AMENDMENT TO THE DRAWINGS

RECYCLING OF A WAFER COMPRISING A BUFFER LAYER AFTER HAVING SEPARATED A THIN LAYER THEREFROM BY MECHANICAL MEANS INVENTORS: Bruno GHYSELEN, et al. ATTORNEY DOCKET NO. 4717-8600; CUSTOMER NO. 28765

MARKED-UP DRAWING SHEET 1/3

FIG.1 (Prior Art)

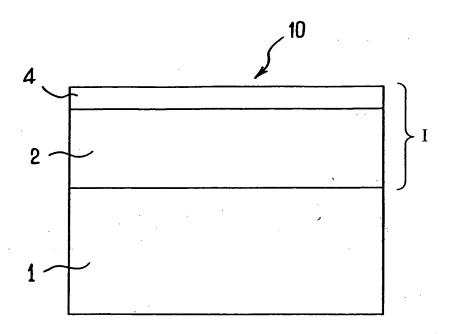
Please amend Figs. 1 and 2 as shown in redline on the attached marked-up drawing sheet.

The specification has been amended in the paragraph beginning on page 24, line 10 to remove the numeral "8," which numeral is not included in the drawings. Figs. 1 and 2 have been amended to include the designation "Prior Art," as proposed by the Examiner. Applicants respectfully maintain that Fig. 3 does not require a similar "Prior Art" designation because Fig. 3 shows a donor wafer after a first recycling step according to the present invention, as explained, for example, in the paragraph beginning on page 11, line 28 of the specification.
